INDIANA DEPARTMENT OF TRANSPORTATION

STANDARDS COMMITTEE MEETING AGENDA

RE: Agenda for the September 21, 2006 Standards Committee Meeting

REVISION TO STANDARD DRAWINGS

STANDARD DRAWING NO. E 610-DRIV-01

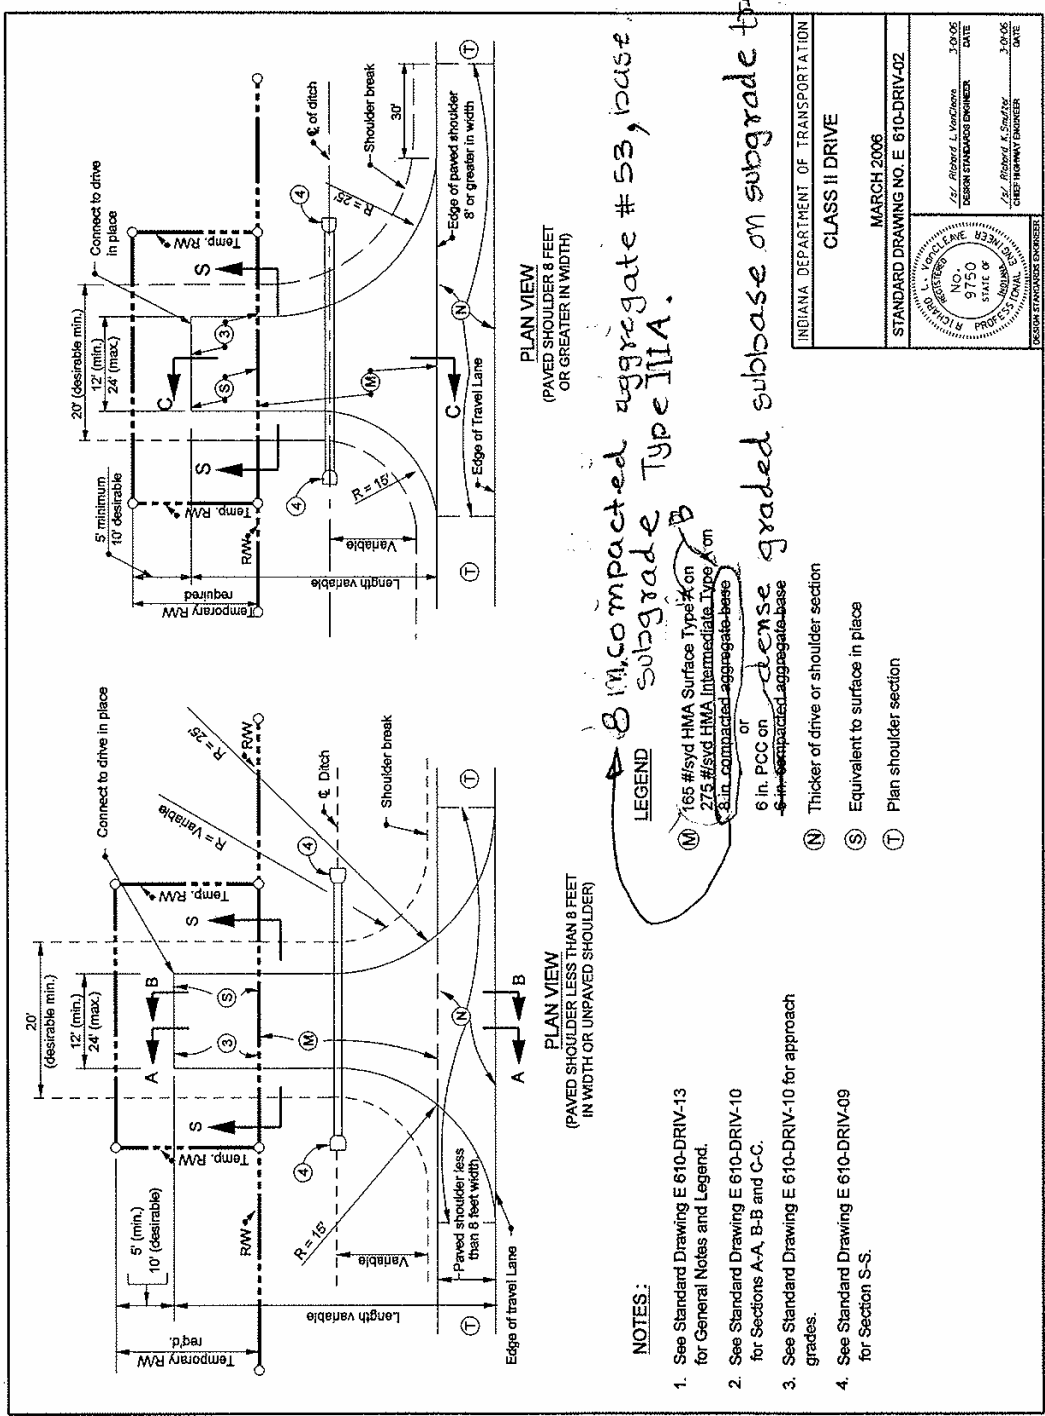
The above listed standard drawings are being revised to reflect thicker pavement sections.

The PCCP thickness for commercial and industrial drives is being changed from 6" PCCP on 6" compacted aggregate base to 9" PCCP on dense graded subbase on subgrade treatment Type IIIA. These drives are designed for 400 trucks per day which also accommodate a WB-65, the Indiana Design Vehicle. The corresponding changes to HMA pavement thicknesses for these drives also have been made. There is no change in the PCCP thickness for residential drives which will remain 6" PCCP thickness as shown currently on the Standard Drawings. The following Standard Drawings, both Metric and English, have been revised to incorporate the PCCP thickness changes for the construction of the drives:

INDIANA DEPARTMENT OF TRANSPORTATION	
CLASS III DRIVE	
MARCH 2006	
STANDARD DRAWING NO. E 610-DRIV-03	
	DATE 3-20-06 DESIGN STANDARD ENGINEER /s/ Richard L. VanCleave
	DATE 3-20-06 CHIEF DRAWING ENGINEER /s/ Richard K. Smutzer

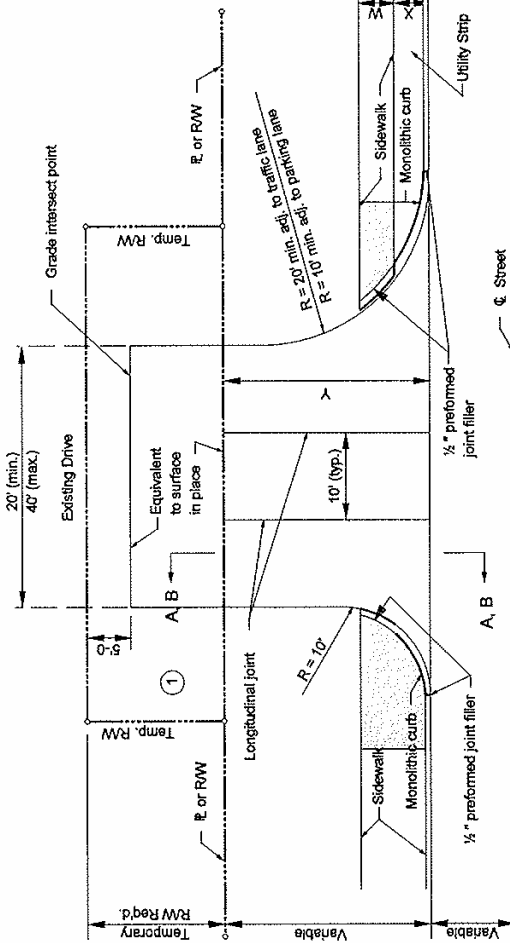
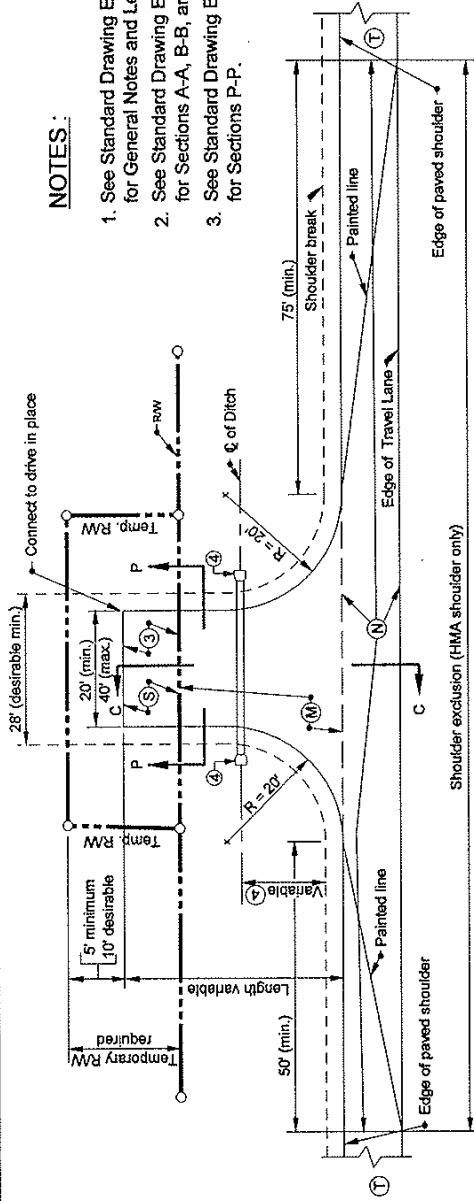
1. See Standard Drawing E 610-DRIV-08 for Section A-A, and Section B-B.
2. For Class III drive, ~~per 91M PCCP~~ **on dense graded subbase** pavement for driveways shall be placed ~~on compacted aggregate base~~ **on subgrade treatment Type IIIA.**
3. See Standard Drawings E 604-SDWK-01 or E 604-SDWK-02 for side walk elevation transition details, or Standard Drawing E 604-SWCR-09 for sidewalk curb ramp details if the drive is signalized.
